HISTORIC AND DESIGN REVIEW COMMISSION

November 04, 2020

HDRC CASE NO: 2020-464
ADDRESS: 227 PALO BLANCO ST
LEGAL DESCRIPTION: NCB 6515 BLK 4 LOT 10
ZONING: R-4, H
CITY COUNCIL DIST.: 3
DISTRICT: Mission Historic District
APPLICANT: Jerry Contreras/CONTRERAS JERRY
OWNER: Jerry Contreras/CONTRERAS JERRY
TYPE OF WORK: Siding repairs, window repairs, skirting installation
APPLICATION RECEIVED: October 12, 2020
60-DAY REVIEW: Not applicable due to City Council Emergency Orders
CASE MANAGER: Huy Pham
REQUEST:

The applicant is requesting a Certificate of Appropriateness for approval to:

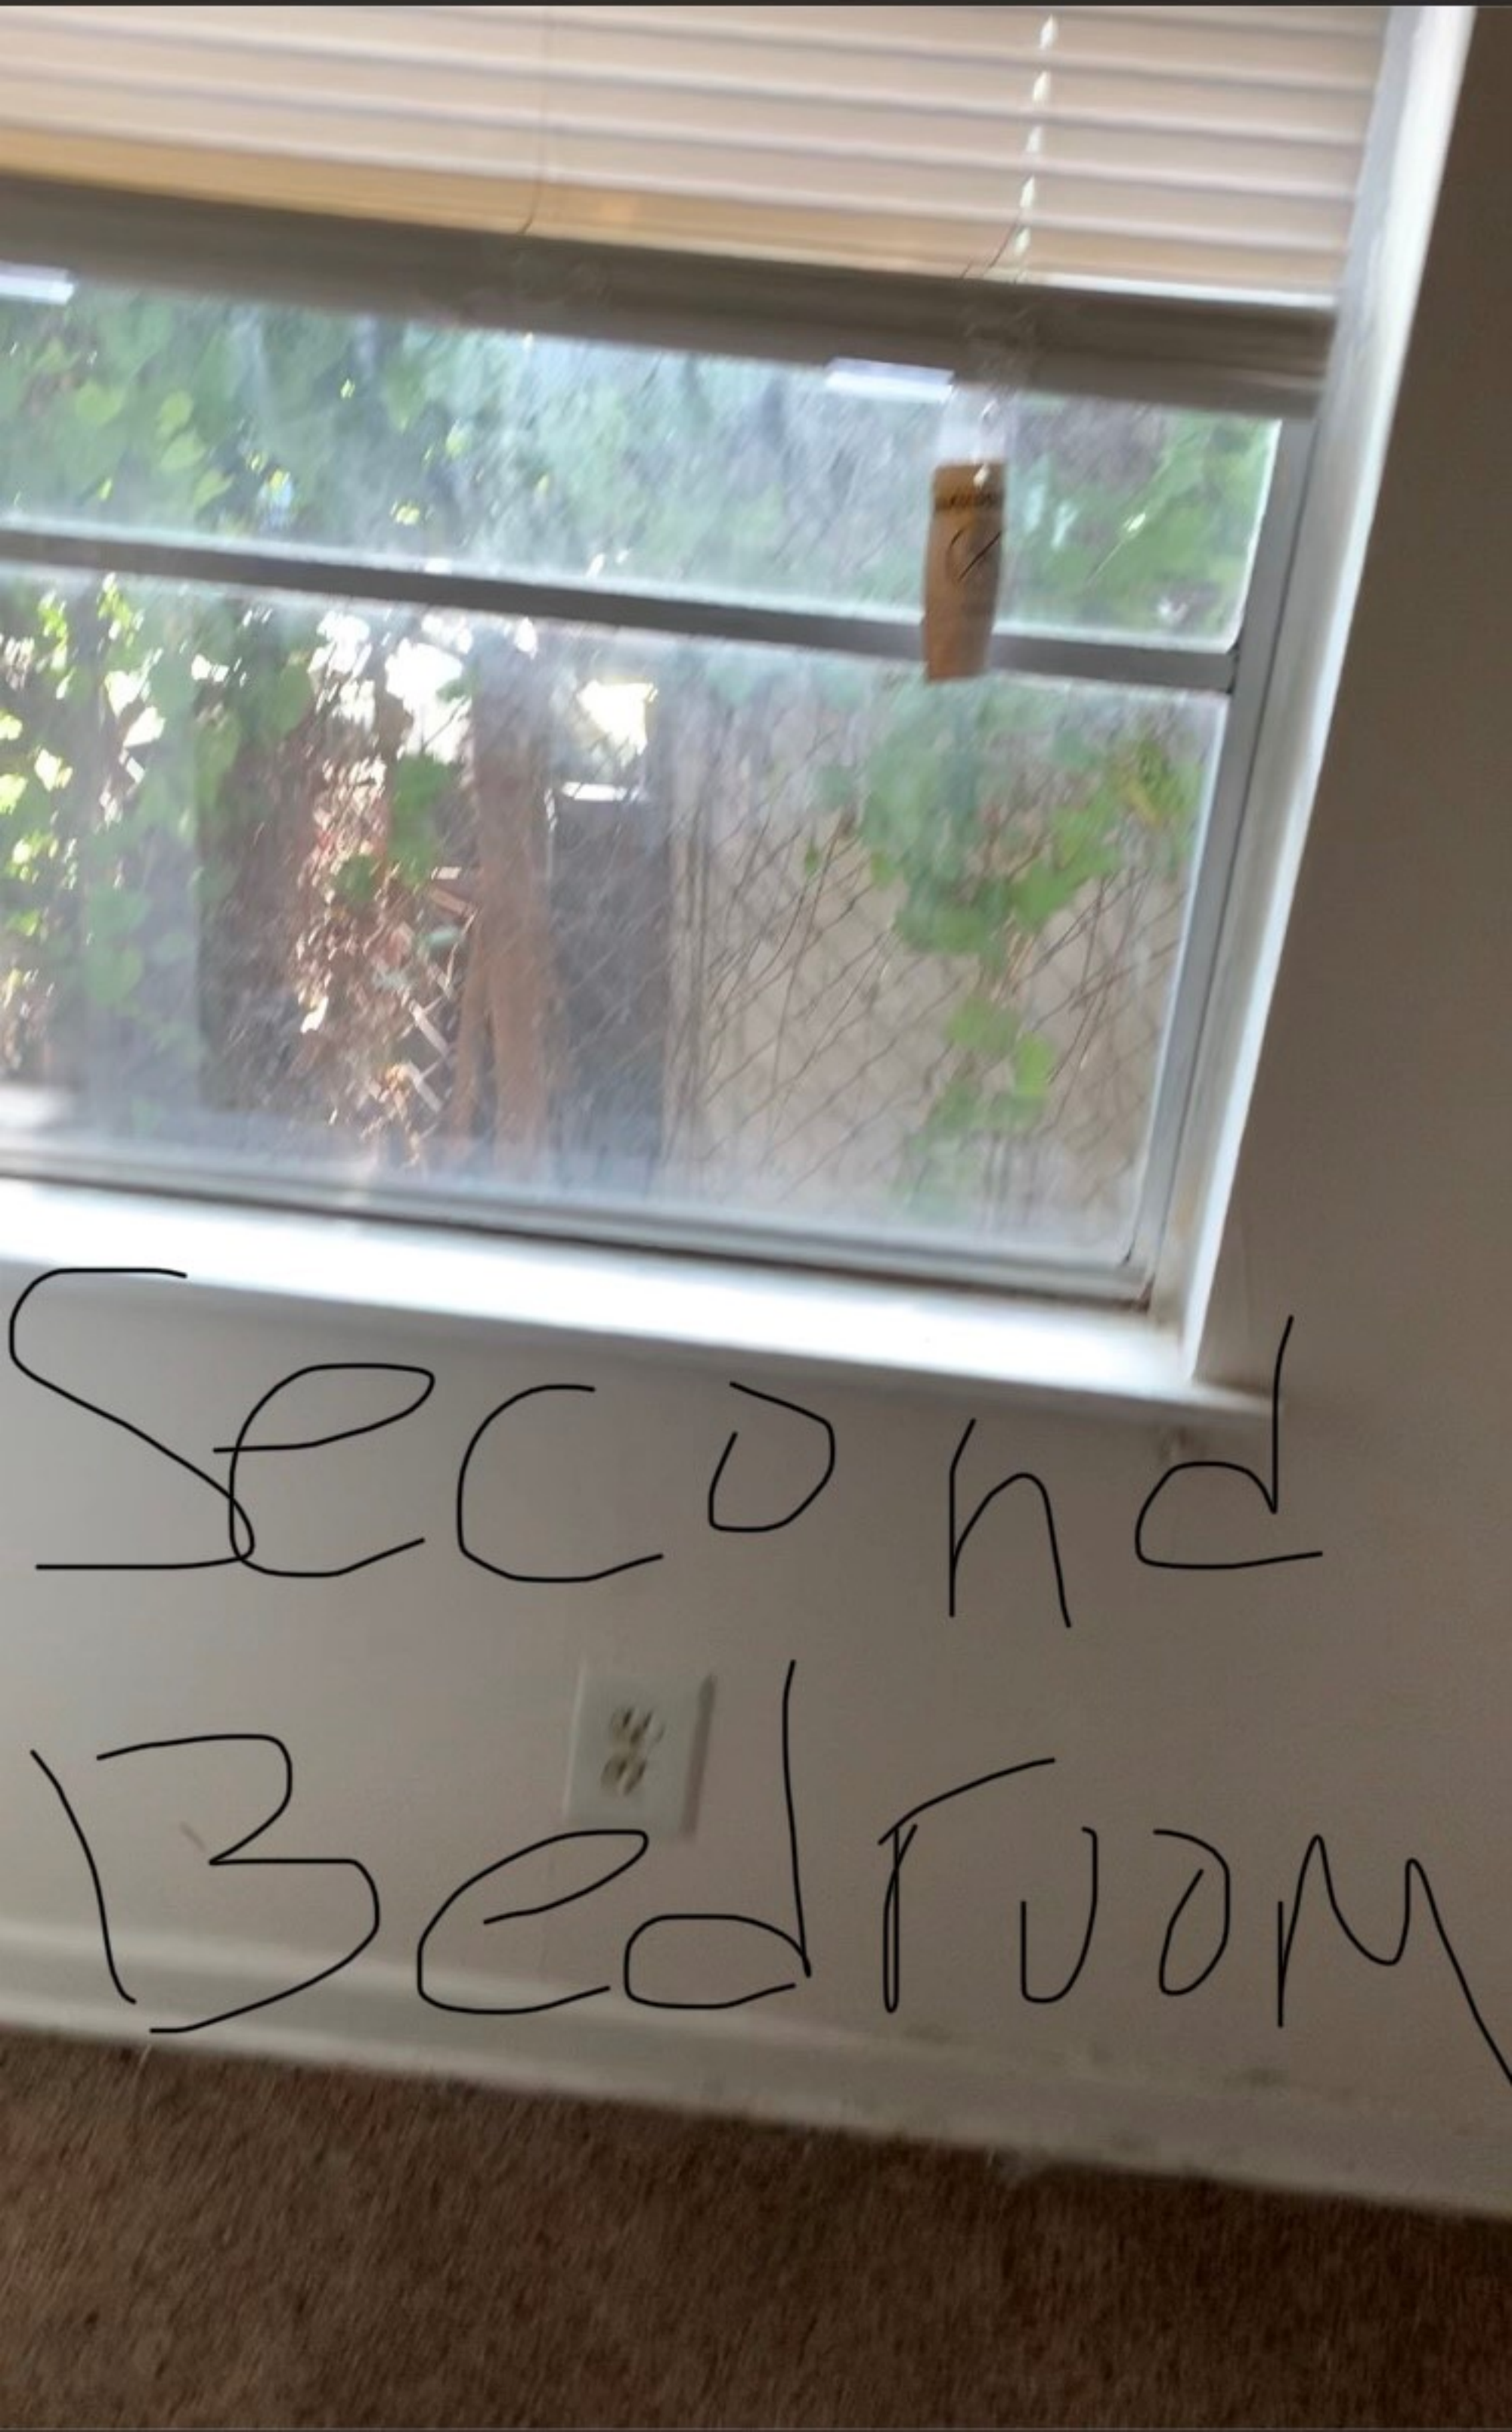
- c. WINDOWS – The applicant has proposed to replace all 7 windows on the structure with new vinyl window (PLYGEM). Staff found that the 2 wood windows remained on site that were in repairable conditions while the other 5 windows were previously replaced with non-conforming aluminum windows. Per the Guidelines for Exterior Maintenance and Alterations 6.B.iv. applicants should replace non-historic incompatible windows with windows that are typical of the architectural style of the building. Per the *Standard Specifications for Original Wood Window Replacement*, where original windows are found to be missing or previously-replaced with a nonconforming window product by a previous owner, an alternative material to wood may be considered when the proposed replacement product is more consistent with the Historic Design Guidelines in terms of overall appearance. Staff finds the proposed new windows are inconsistent with the Standard Specifications regarding the sash profiles, faux divided lites, and nailing fin configuration. Staff finds the 2 wood windows should be restored or replaced in-kind if discarded, and that the other 5 windows should be replaced with a window product that meets the *Standard Specifications for Original Wood Window Replacement*, regardless of material.

Staff does not recommend item 1. Window replacement as proposed based on finding b and c. Staff recommends restoration of the 2 wood windows remaining on site whereas the other 5 windows are eligible for replacement with a window product that adheres to *Standard Specifications for Original Wood Window Replacement* with the allowance of a non-wood product if all other specifications are met.
